**GOVERNMENT/INDUSTRY AERONAUTICAL CHARTING FORUM**  
**Instrument Procedures Group**  
**April 29-30, 2002**  
**HISTORY RECORD**

**FAA Control # 02-01-245**

**Subject: Along-Track-Distance (ATD) Step-down Fixes for RNAV Approaches with Published LNAV-only and LNAV/VNAV Minima.**

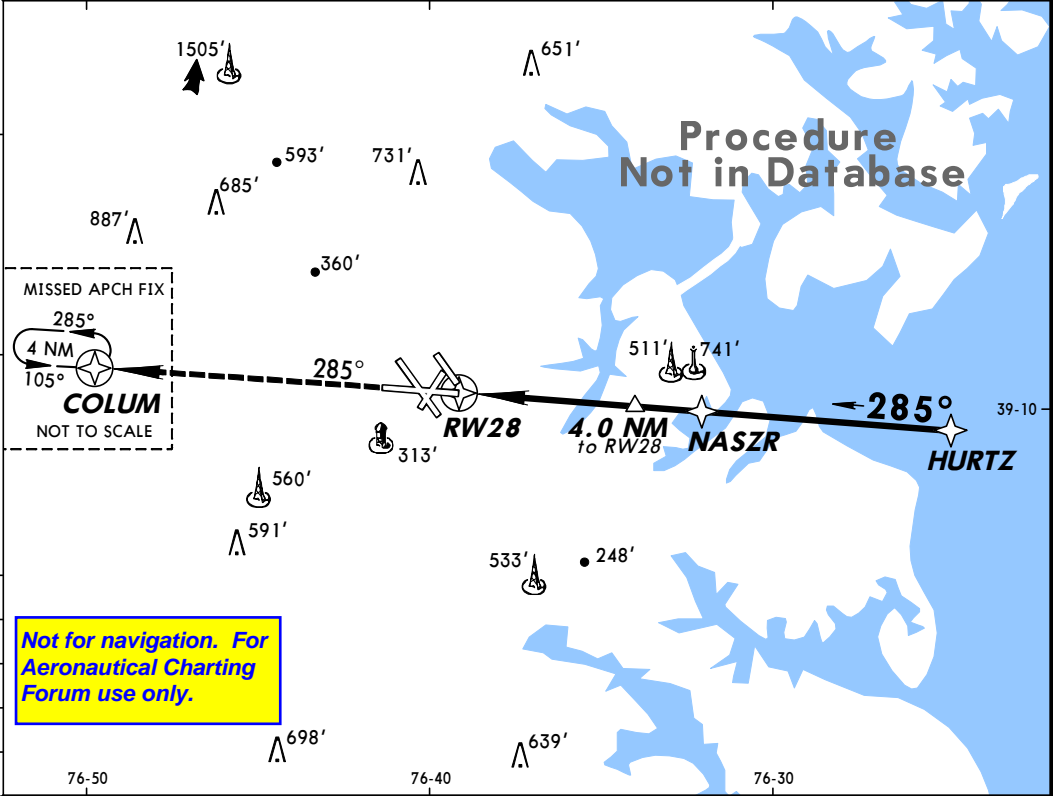
To address this issue, the FAA has (in certain locations) developed RNAV (GPS) Y and Z approaches to the same runway. An example that illustrates this can be found at the Baltimore-Washington International Airport (KBWI). For runway 28, RNAV (GPS) Y and Z approaches are published. The “Y” approach (see attached) has both LNAV-only and LNAV/VNAV minima, and the stand-alone LNAV MDA is 677 feet. The “Z” approach (see attached) was developed with LNAV-only minima. The difference between the two approaches is that the “Z” approach has a step-down fix in the final approach segment. Because of this, the LNAV MDA for the “Z” approach is 317 feet, or 360 feet lower than the “Y” approach that contains no step-down. The publication of this “Z” approach would solve GA’s dilemma in this instance; however, this “Z” approach does not appear in the databases of GPS units used by GA. In short, GA pilots suffer the same penalty as that faced in the Carlsbad scenario where only a single approach plate was published.

**Option 2:** Publish a “Y” and “Z” approach in each instance where it is necessary to accommodate both LNAV-only minima with step-down fixes and LNAV/VNAV procedures (as was done at KBWI).

**MEETING 02-02:** Tom Schneider, AFS-420, led the discussion on this issue. The group consensus was that stepdown fixes should be developed for LVAN/VNAV procedures with LNAV minima when lower LNAV minimums may be achieved. All agreed that publishing a single procedure with stepdown fix is preferable to publishing two procedures with alphabetical suffixes. Steve Bergner supported publishing these fixes as ATD only without names. Jim Terpstra, Jeppesen, recommended the fixes be named. Bill Hammett, AFS-420 (ISI), suggested that CNFs be used in lieu of pronounceable names. Jim agreed that this would be acceptable. Jim also stated that LNAV/VNAV users could ask database developers to strip the stepdown fix from the string. He also stated that stepdown fix altitudes must specify at-or-above altitudes and not provide steeper descent gradients inside the stepdown fix wherever possible. Kevin Comstock, ALPA, questioned if LNAV would be impacted; Jim assured him it would not. AFS-420 and AVN-160 will jointly work policy issues for Order 8260.19. The consensus was that the issue could be closed. **ITEM CLOSED.**
